**Appln No. 09/522,185
Amdt date June 15, 2004
Reply to Office action of March 31, 2004**

REMARKS/ARGUMENTS

FIG. 3

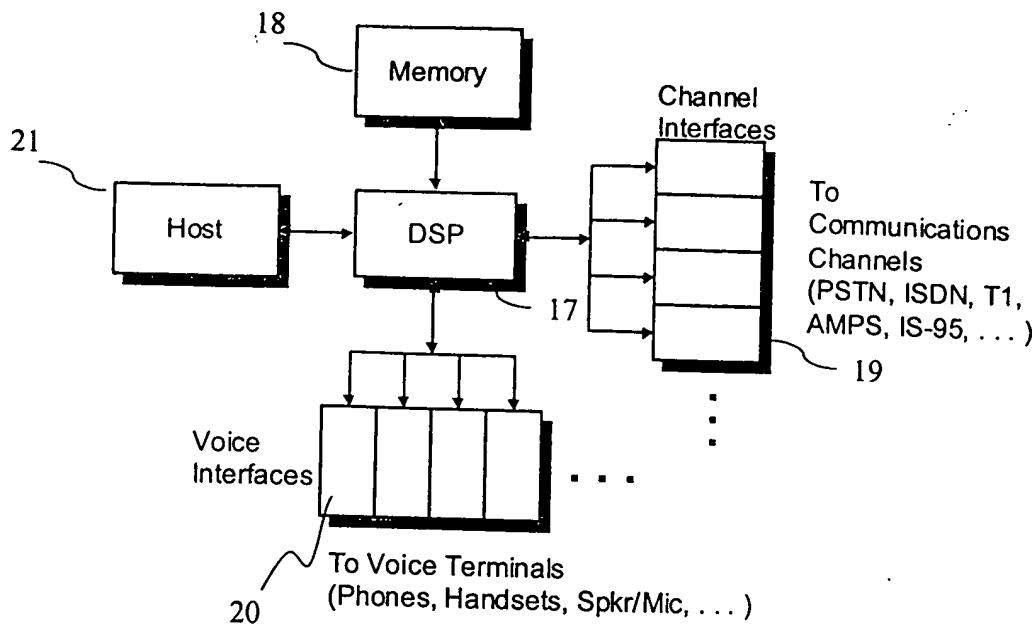
Claims 1-94 are pending. Claims 1, 26, 49, and 74 are amended. FIG. 3 is amended to correct a typographical error, that is changing the reference numeral 25 to 27. Specification is also amended to correct typographical errors.
